# CITY OF PORTLAND BUILDING PERMIT

210 VALLEY ST

**PERMIT ID:** 2012-65554

has permission to **Buildout basement - Adding two bedrooms**

**UNIT 1 additional 2 rooms in basement**

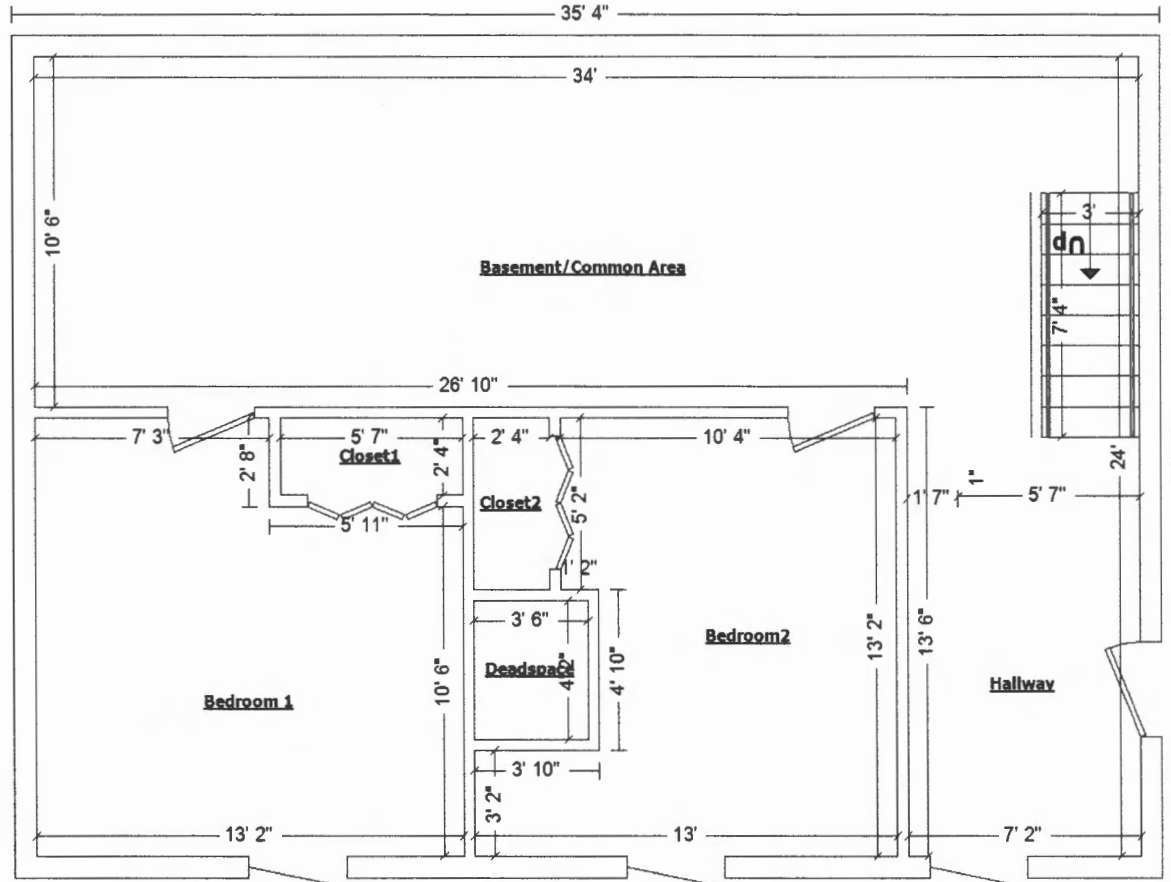
- Where are the doors for each proposed bedroom located? **Corrected drawing submitted**
- What is the "Deadspace" build-out in bedroom 2? **There is a non-working chimney in the basement**

Not disturbing stairs

Percent of work within unit is 43% to entire unit.

Fire rated ceill tiles supplied by homeowner

Cross Section of Basement walls 210 Valley St, Portland Maine

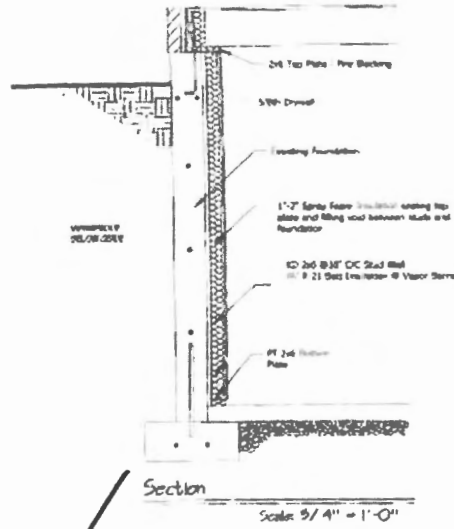
Prior to building permit issuance, our office needs a cross section of the typical wall detail, columns, and concrete work. Below are items that need to be identified on the plan.

Unless there is some reason to use all PT framing that I am not aware of, we would frame the 2 x 6 walls in the basement using KD lumber, with PT for the sill plates only.

# 210 VALLEY ST UNIT 1 additional 2 rooms in basement

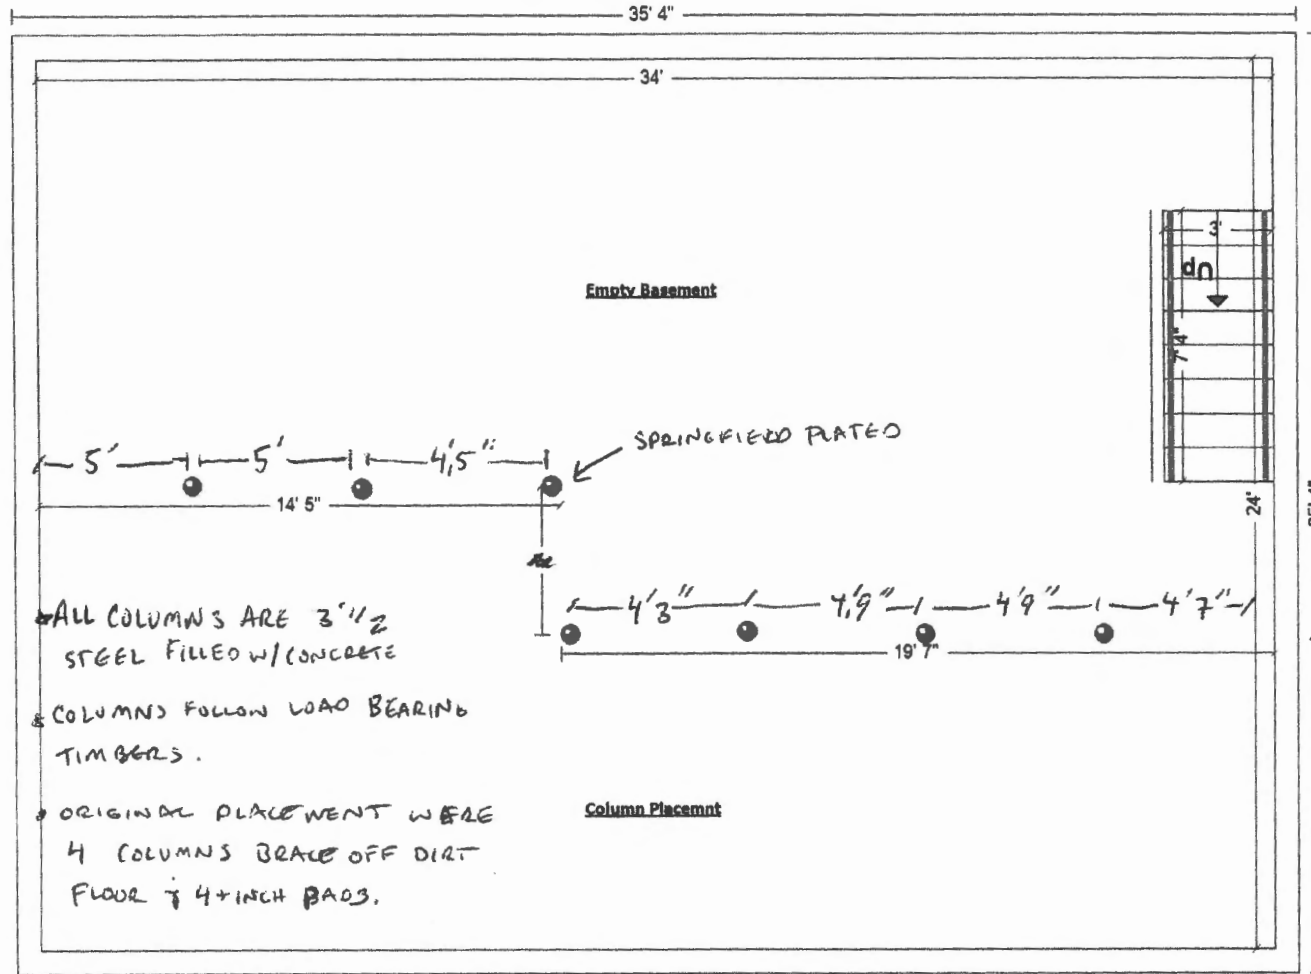
Are the columns in the existing location or did you move the Girder at the half-way point? If the Girder was moved we need to make sure the floor joist above are spanned adequately.

- All columns are 3 1/2" steel filled w/ concrete
- Columns follow load bearing timbers.
- Original placement were 4 columns brace off dirt floor & 4 inch pads.
- 18" precast 6" thick discs with 18" precrushed ~~the~~ material, compacted every 6" 1 ft. ~~at~~ (before 6" precast disc)

Thank you. We did not move anything. This is the layout of the girder system and nothing was moved. A Springfield plate was installed with column were there wasn't any support. Originally there were only 4 post and not one was sufficient for it's intended purpose. My boss who is an engineer decided we need to add more than typical do to the girder system.  
Thanks again. Feel free to call or email with any questions or concerns.
